Addendum to iScan VP30 Owner's Manual

Page 7:

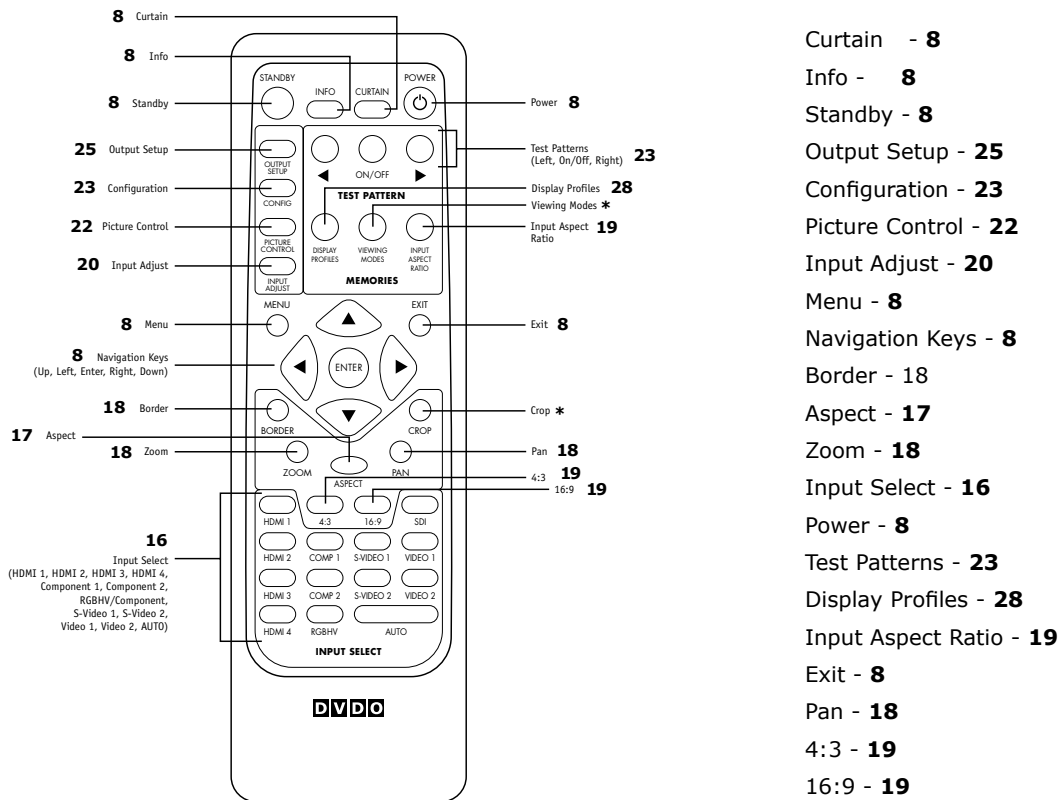
Some of the page numbers are incorrect. Please refer to these page numbers for more info about the functionality of these buttons:
